IN THE UNITED STATES PATENT AND TRADEMARK OFFICE

Applicant: Dardo Bonaparte Lujan
Serial Number: 10/791,054
Filing Date: March 2, 2004
Title: Armored Assembly
Examiner: Troy Chambers
Art Unit: 3641

RESPONSE TO OFFICE ACTION

Fig. 16

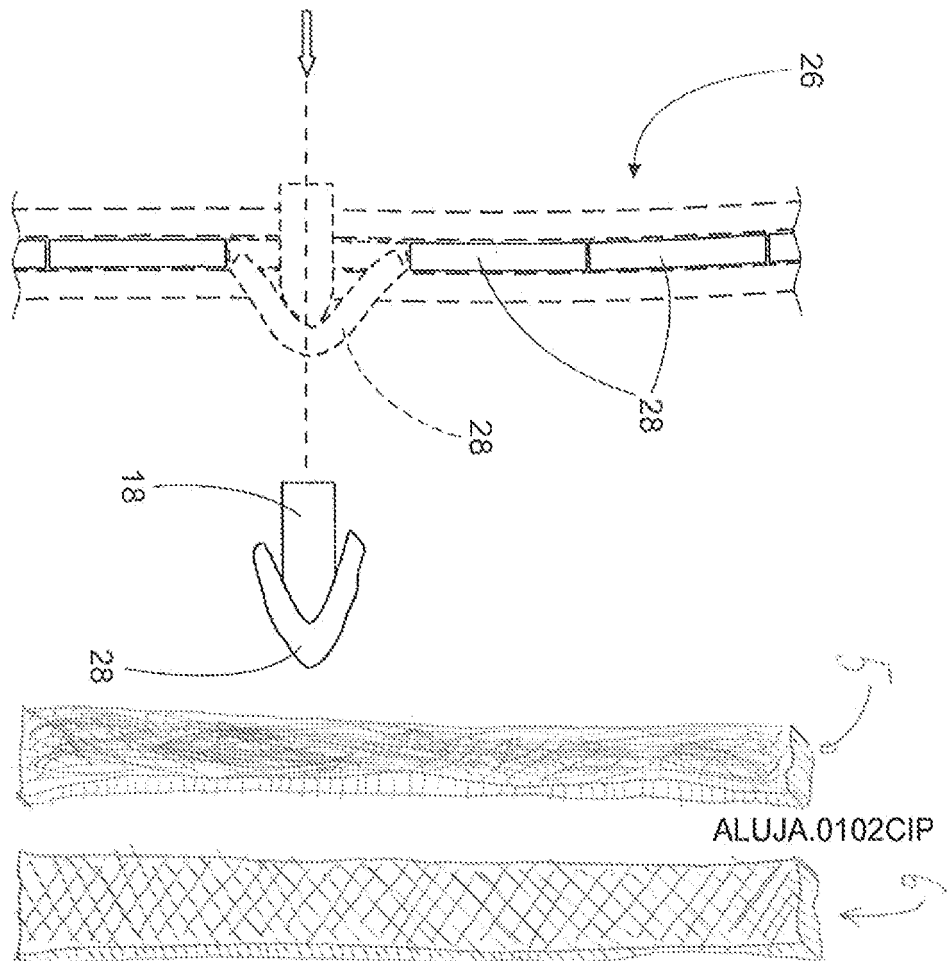
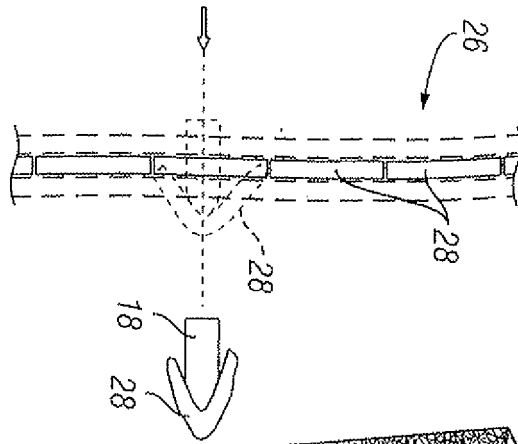
The attached sheet of drawings includes changes to Fig. 16. This sheet, which includes Fig. 15-16, replaces the original sheet including Fig. 15-16. In Fig. 16, elements 5 and 6 from Fig. 1 have been added to Fig. 16.

In the Office Action, the Examiner has again objected to the drawings under 37 CFR §1.83(a) in that the drawings are deemed not to show every feature of the invention. Specifically, the Examiner contends that the “at least one projectile stopping panel” (Claims 15, 16), “the impact cushioning panel” (Claim 28), and “the projectile stopping panel comprising loosely-entangled fibers” (Claim 29) are not shown in the drawings. In the previous Office Action, Applicant pointed out to Examiner that these features were already shown in FIGS. 1 and 9. During an informal telephone conversation with Examiner on August 8, 2006, Examiner noted that these features are not shown in FIGS. 15 and 16, which represent specie E elected with traverse by Applicant pursuant to a restriction requirement. Examiner also stated that he would not look outside FIGS. 15 and 16 for the above referenced features.

Pursuant to Examiner’s suggestion that he will not look at any other figures other than FIGS. 15 and 16 for the features of the invention, replacement drawing sheets are attached to this response clearly depicting the “at least one projectile stopping panel” (Claims 15, 16), “the impact cushioning panel” (Claim 28), and “the projectile stopping panel comprising loosely-entangled fibers (Claim 29) in FIG. 16. Specifically, the “at least one projectile stopping panel” and “the projectile stopping panel comprising loosely entangled fibers” are identified by reference numeral 5. The “impact cushioning panel” is identified by reference numeral 6.

No new matter has been entered because these amendments to the drawings are clearly supported by the original disclosure. In paragraph 0069 of the published application, the description of FIG. 16 states that the bullet is “trapped into the mass or against the surface of any further ballistic panel, such as the panels of FIGS. 1 and 9.” Therefore, the ballistic panels of FIGS. 1 and 9 are incorporated by reference into the description of FIG. 16. Consequently, FIG. 16 has been amended to include the ballistic panels identified by the reference numerals 5 and 6

Paragraph 0042 of the published application refers in the description of FIG. 1 to “at least one projectile-trapping panel 5.” Likewise, the specification at paragraph 0070 refers to “at least one projectile-stopping panel, or trapping panel”, which indicates that the terms “projectile trapping panel” and “projectile stopping panel” are used interchangeably. Such panel is now clearly depicted in FIG. 16 and identified by the reference numeral 5.

The “projectile stopping panel comprising loosely entangled fibers” in claim 29 is also shown in FIG. 16. Applicant respectfully refers Examiner to the preceding paragraph indicating that the terms “projectile stopping panel” and “projectile trapping panel” are used interchangeably. To the extent Examiner believes that the “loosely entangled fibers” portion of claim 29 is not shown, Applicant refers Examiner to paragraph 0055 of the specification, wherein it is disclosed that “the projectile-trapping panels 5 ... may comprise a mass of loosely-entangled microfibers 15, FIGS. 1 and 2.” The same paragraph goes on to state that “the term ‘microfiber’ must be understood as encircling all kind of fibers, filaments, threads and the like.” The term “loosely entangled” is defined in paragraph 0057 of the specification. The term “loosely entangled” is also described and claimed in U.S. Patent No. 6,684,468, col. 4, l. 45 through col. 5, l. 12 and claim 1. Therefore, “the projectile stopping panel comprising loosely entangled fibers” in claim 29 is now depicted in FIG. 16 and identified by reference numeral 5.

Applicant also respectfully submits that the “impact cushioning panel” referred to in claim 28 is now shown in FIG. 16. In paragraph 0043 the specification discloses “at least one impact cushioning panel 6, see FIG. 1”. Again, Applicant respectfully refers Examiner to the description of FIG. 16, paragraph 0069, which also refers to FIG. 1 and incorporates the ballistic panels of FIG. 1 by reference into the description of FIG. 16. Because the “impact cushioning panel”, “the projectile stopping panel”, and “the projectile stopping panel comprising loosely entangled fibers” originally shown in FIG. 1 are now shown in FIG. 16 and identified by the reference numerals 5 and 6, Applicant requests that Examiner withdraws his objection under 37 C.F.R. 1.83(a) that these features are not shown in the drawings.
